Re: Cost Change Proposal Number 2, 57831683-22 Cathodic Protection Program FY22

Change of Contract Price Proposal No.2

Cathodic Protection Program FY22

Fig 1: Benching Requirements per OSHA 1926 Subpart p App B Sloping and Benching, Excavations made in Type B Soil

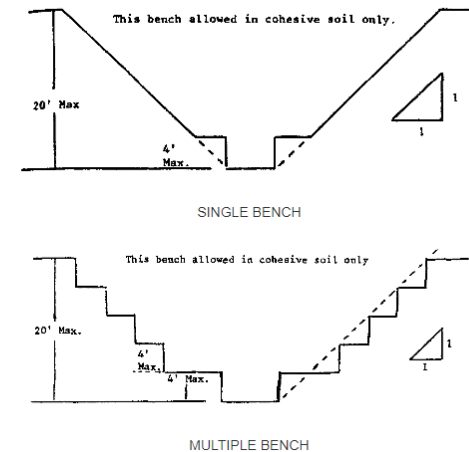
Requirements for benching size and spacing are determined by soil type; these excavations have been in type B soils, requiring a 1:1 height to width ratio (*Figure 1*).

2. All benched excavations 20 feet or less in depth shall have a maximum allowable slope of 1:1 and maximum bench dimensions as follows:
